[Docket No. FAA-2007-28661; Directorate Identifier 2007-NM-013-AD]

#### Airworthiness Directives; The Boeing Company Model 737-600, -700, -700C, -800, and -900 Series Airplanes

**ACTION:** Supplemental notice of proposed rulemaking (NPRM); reopening of comment period.

Figure 1

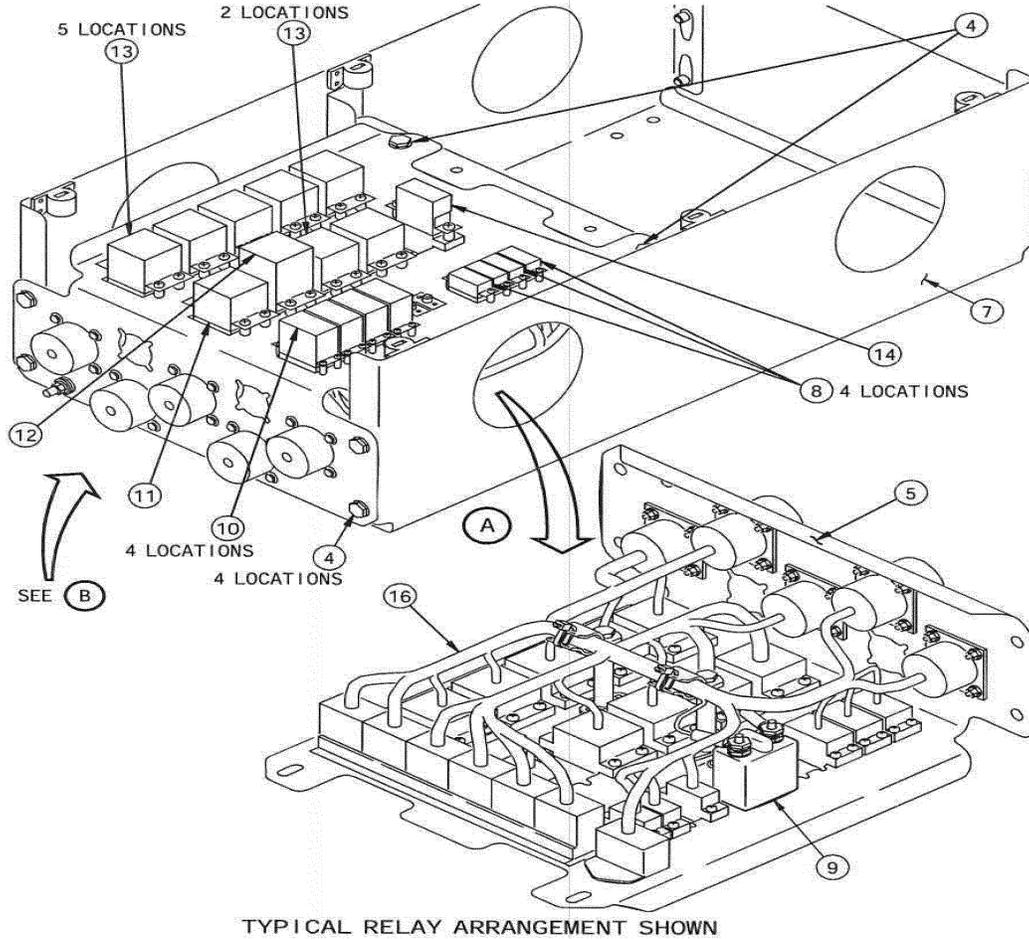
- Sheet 2 of 4 of Figure 11 of Boeing Alert Service Bulletin 737-28A1206, Revision 2, dated May 21, 2009, was inadvertently replaced with Sheet 2 of 4 of Figure 11 from Boeing Alert Service Bulletin 737-28A1206, dated January 11, 2006. That figure was corrected in Boeing Alert Service Bulletin 737-28A1206, Revision 1, dated January 30,

2008, and did not need to be changed in Boeing Alert Service Bulletin 737–28A1206, Revision 2, dated May 21, 2009. We have added Figure 1 in this supplemental NPRM to provide the correct Sheet 2 of 4 of Figure 11.
